NHIDCL/Gholteer Landslide/NH-07/2018

Subject: Construction and Upgradation including specialized slope treatment and augment of existing road from Km. 379+100 to Km. 380+275 (approx. 1.175 km) on Gholteer Landslide of National Highway No. 07 (hereinafter called the "NH -07") in the state of Uttarakhand

Replies to Bidder Queries			
Sr.No	Reference/Clause No.	Pre-Bid QUERY	Reply
1.	General	The details of available ROW for the project need to be clarified.	As per Annexure-II of Schedule-A

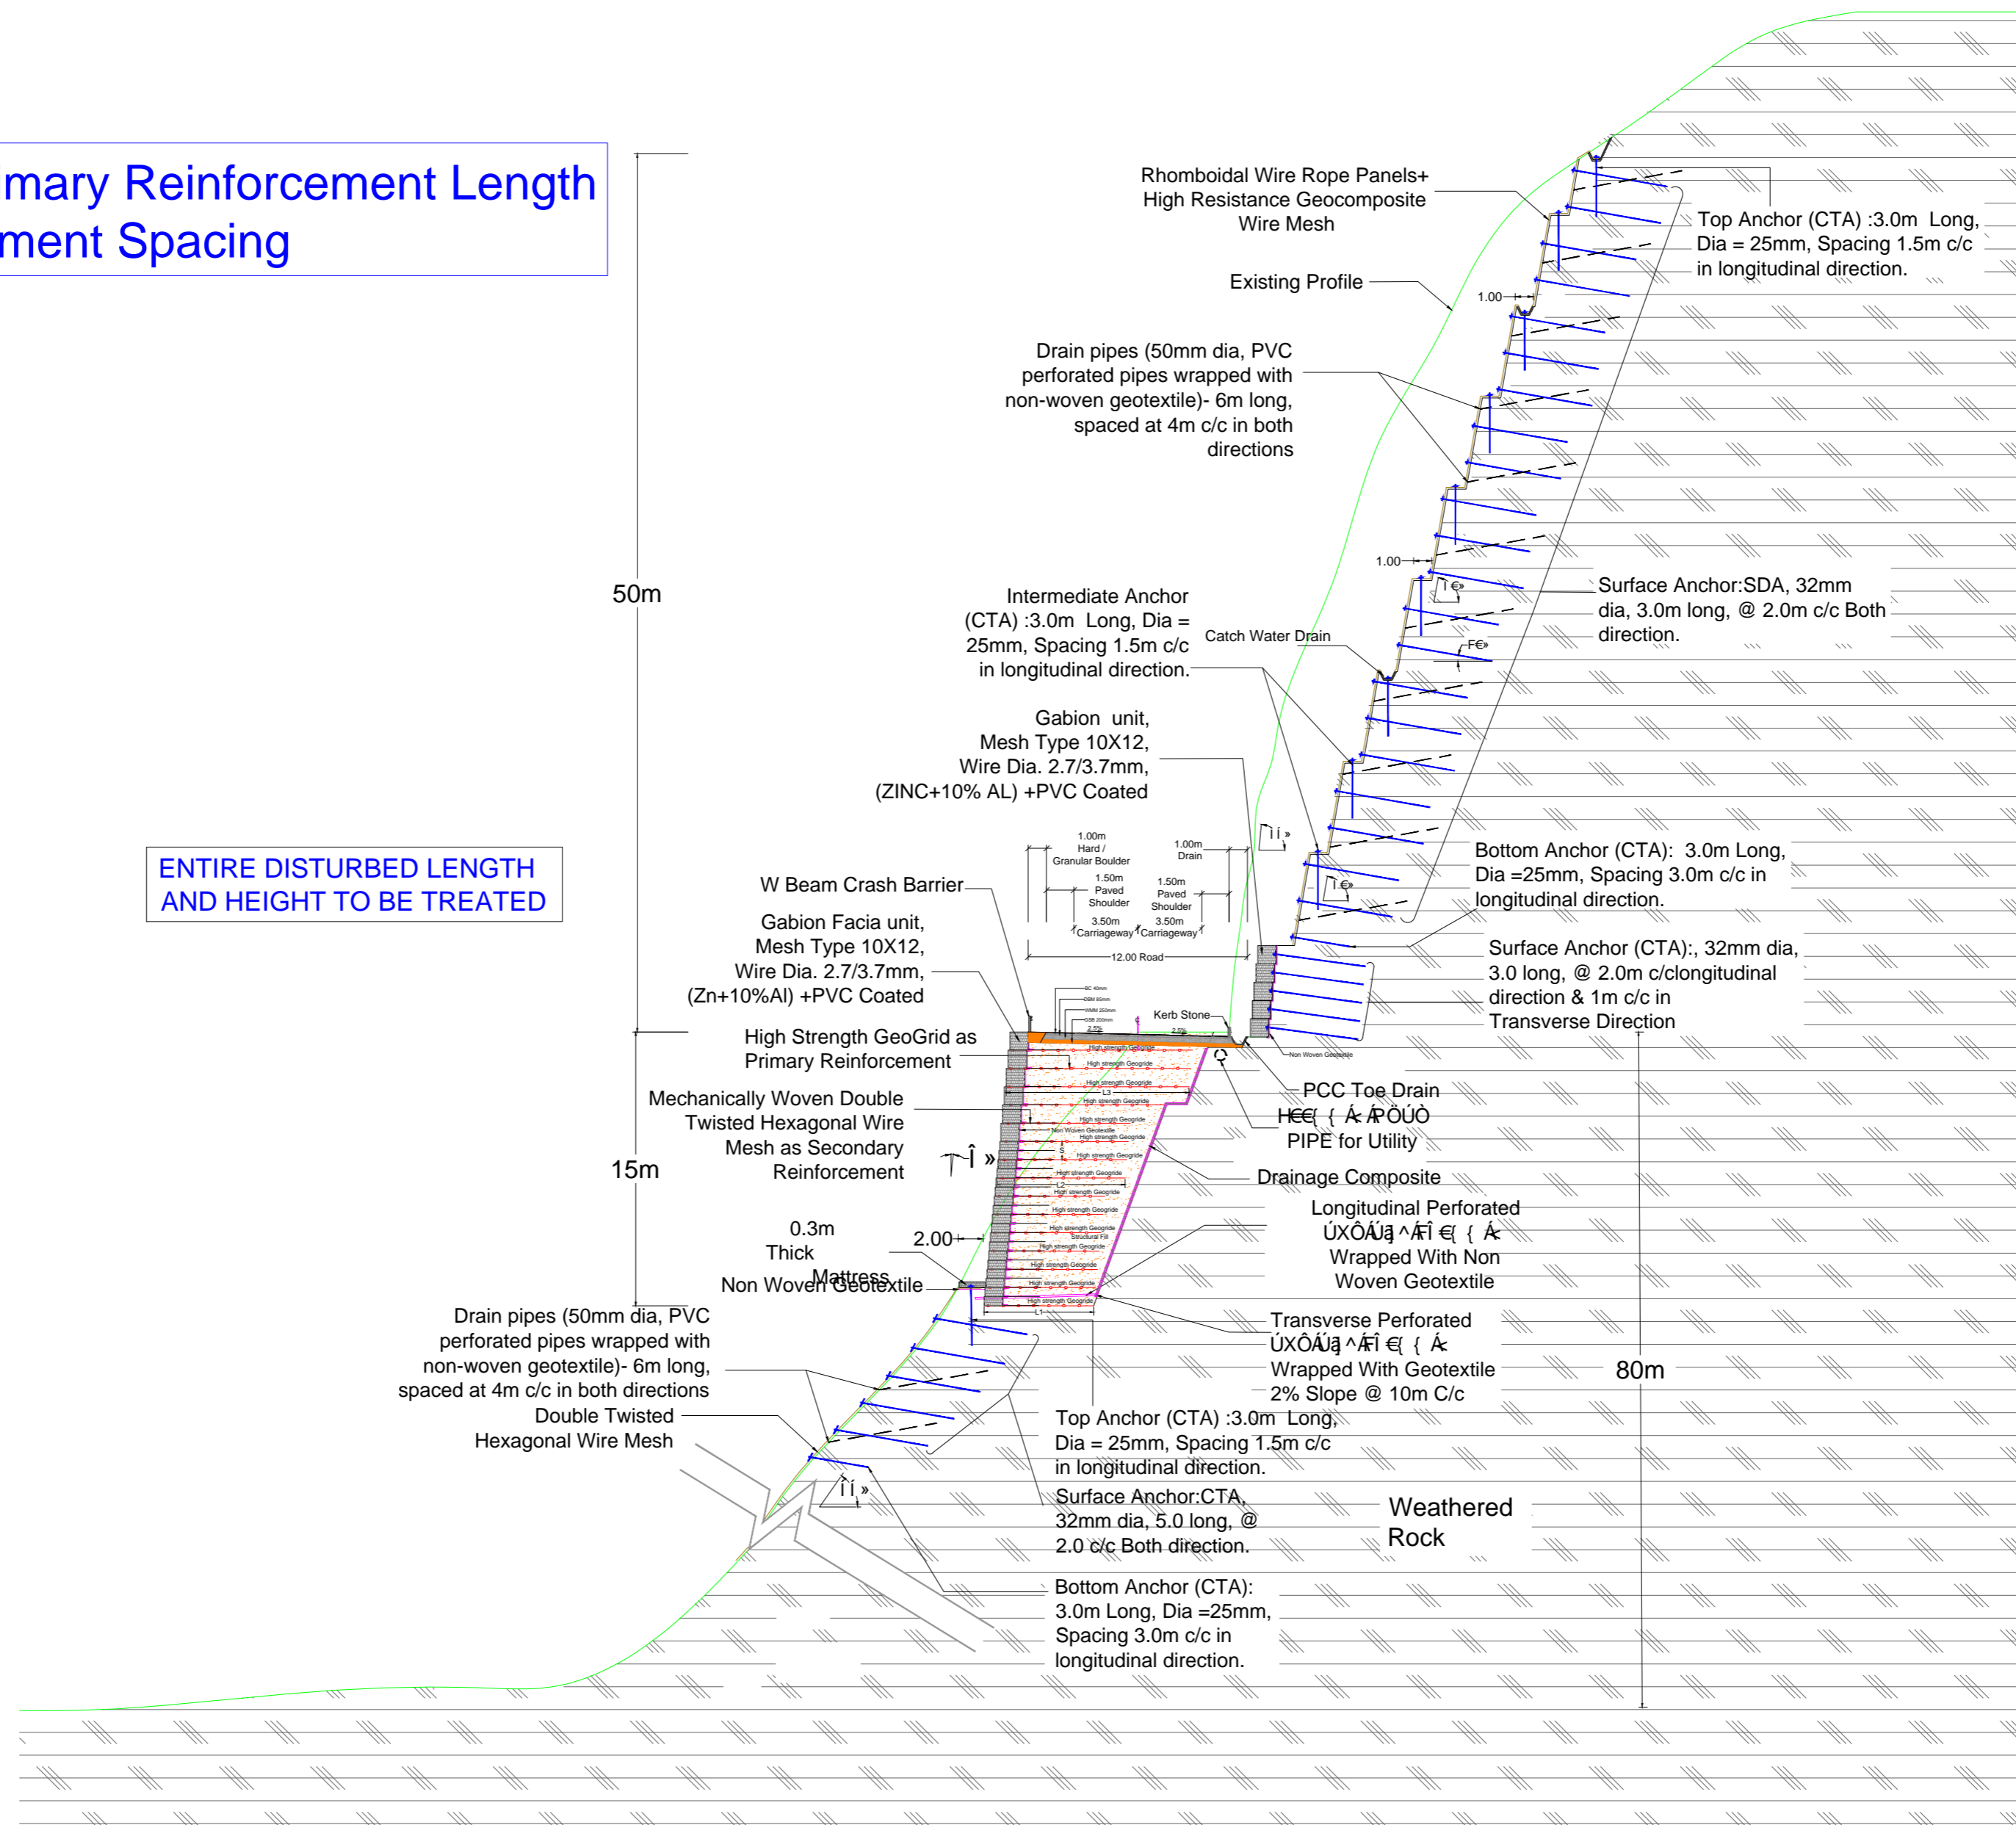
8	Schedule-A , Annexure-I The Site of the Project Highway comprises the land (sum total of land already in possession and land to be possessed).	The authority is requested to clarify regarding the land availability for the entire project length between Km 379+100 to 380+275.	As per Annexure-II of Schedule-A
9	Schedule-B, Annexure-I Minimum Provisions of Gabion retaining wall in a length of 141 m Reinforcement soil wall in a minimum length of 779 m, Gabion breast wall in a minimum length of 1104 m, Secured Drapery System with Synthetic erosion control mat and Hydraulically applied erosion control Measures in a minimum length 975 m have been recommended.	The secured drapery works are always defined on the Sq.m of area to be covered and the estimate is entirely dependent of the stretch length and average height of the slope to arrive at a cost. Further, the Retaining wall structures like Gabion walls / Reinforced soil wall estimate is dependent of the height of retaining structure and stretch length. Hence, we request to please provide the Average height of the secured	DPR has already been uploaded

drapery system and height of retaining / reinforced soil walls along with stretch length to arrive at the right estimate of work.	
10.	The complete Bidding Documents including the draft Agreement for the Project is enclosed for the Bidders. The Feasibility Report/ Detailed project Report Presented by the Authority / Consultants of the Authority (The "Feasibility Report/ Detailed Project report") are also enclosed.	Feasibility report is not included in the tender document and hence we request to share the same.	DPR has already been uploaded
11.	<b>Additional Information "General"</b>	<b>Schedule-B</b>	As per drawing 30-40 m height which intends to cover the entire disturbed slope as slope protection measure. A rough schematic diagram is enclosed.
12	<b>Additional Information Annexure-A</b>	<b>Schedule-B</b>	Modified Annexure-A of Schedule-B is enclosed
